DEVELOPMENT APPLICATION ASSESSMENT REPORT

DA2024/1769

Application Italibori	D7 12 02 17 17 00		
Responsible Officer:	Julie Edwards		
Land to be developed (Address):	Lot 15 DP 4449, 13 Baltic Street FAIRLIGHT NSW 2094		
Proposed Development:	Alterations and additions to a dwelling house		
Zoning:	Manly LEP2013 - Land zoned R1 General Residential		
Development Permissible:	Yes		
Existing Use Rights:	No		
Consent Authority:	Northern Beaches Council		
Delegation Level:	DDP		
Land and Environment Court Action:	No		
Applicant:	Lachlan Charles Hudson Baker		
Application Lodged:	15/01/2025		
Integrated Development:	No		
Designated Development:	No		
State Reporting Category:	Residential - Alterations and additions		
Notified:	27/01/2025 to 10/02/2025		
Advertised:	Not Advertised		
Submissions Received:	0		
Clause 4.6 Variation:	4.3 Height of buildings: 12.9% 4.4 Floor space ratio: 12.73%

Image 1: Building height non-compliance shaded in red.

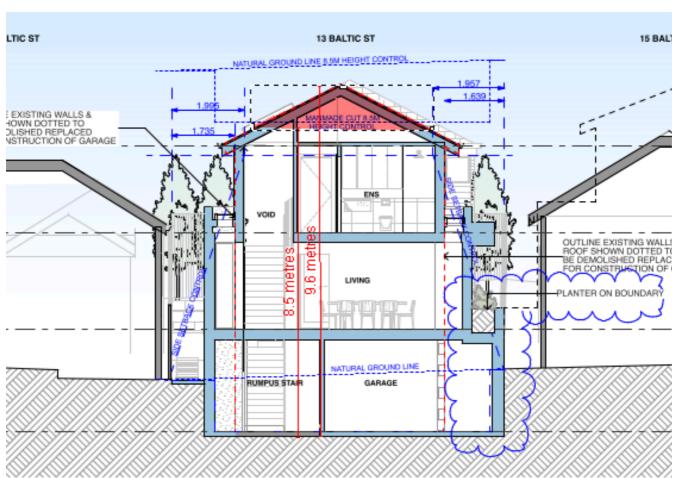
The Clause 4.6 request for the non-compliance with height standard arises from the alteration to the roof over the north facing level 2 terrace, which results in a 12.35% variation. The proposal maintains the height of the existing roof.

Requirement: 8.5m Proposed: 9.6m

Percentage of variation: 12.35%

Image 4: Level 1 - western side boundary setback non-compliance.

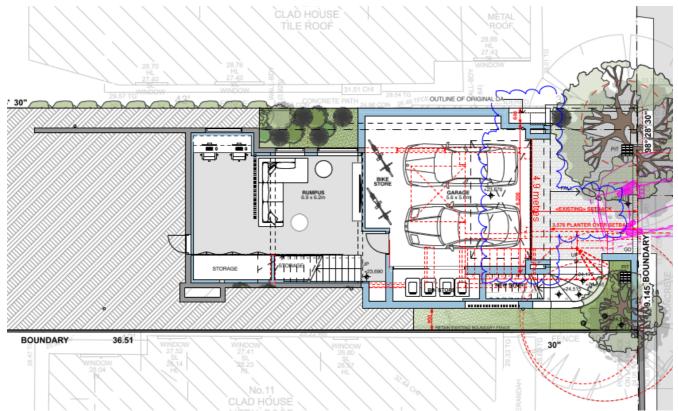
- i) contain no windows; *
- ii) be constructed to one side boundary only;
- iii) limit height to 3m; *
- iv) limit length to 35 percent of the adjoining site boundary; **
- v) submit a standard of finish and materials for external surfaces which complement the external architectural finishes of adjacent properties and/or the townscape character;
- vi) obtain a right-of-way to provide access for maintenance; and
- vii) satisfy the objectives for setback in this plan and the applicant can demonstrate no disadvantage to the adjacent allotment through increased overshadowing, or loss of view and no impediment to property maintenance.

The proposed encroachment on the western elevation meets these requirements and can be considered for a variation.

Image 5: Level 2 - front boundary encroachment highlighted in red.

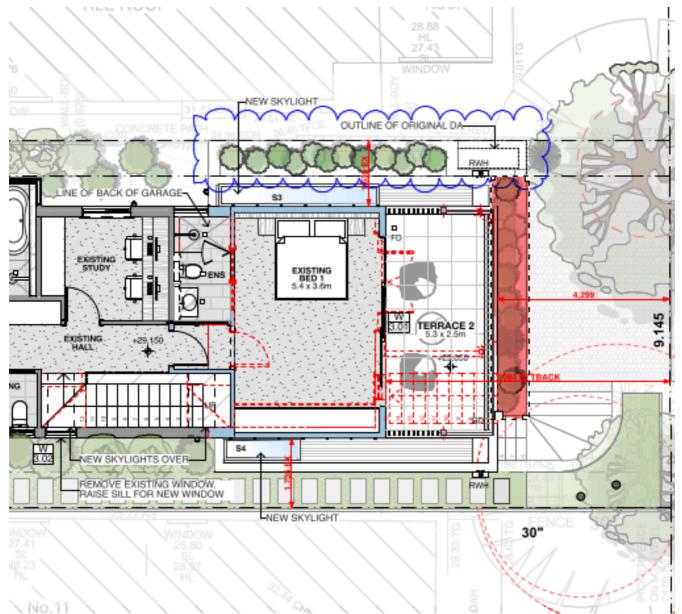
The proposed level 2 planter box is 3.5m from the front boundary. The remainder of the development

The proposed first floor planter box and supports are forwarded of the existing building line. While the planter box does not meet the requirement, the planter box will soften the appearance of dwelling when viewed from the street and adjoining dwellings.

North Elevation

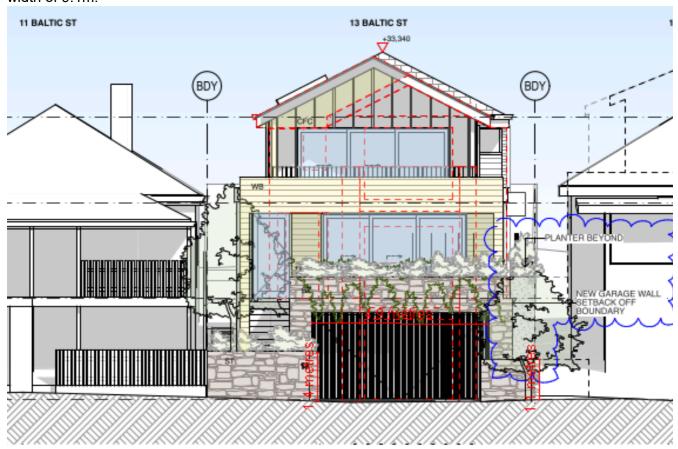
c) the maximum width of any garage, carport or hardstand area is not to exceed a width equal to 50 percent of the frontage, up to a maximum width of 6.2m.

The width of the garage door is 4.9m, which is non-compliant with the width control as the site has width of 9.1m.
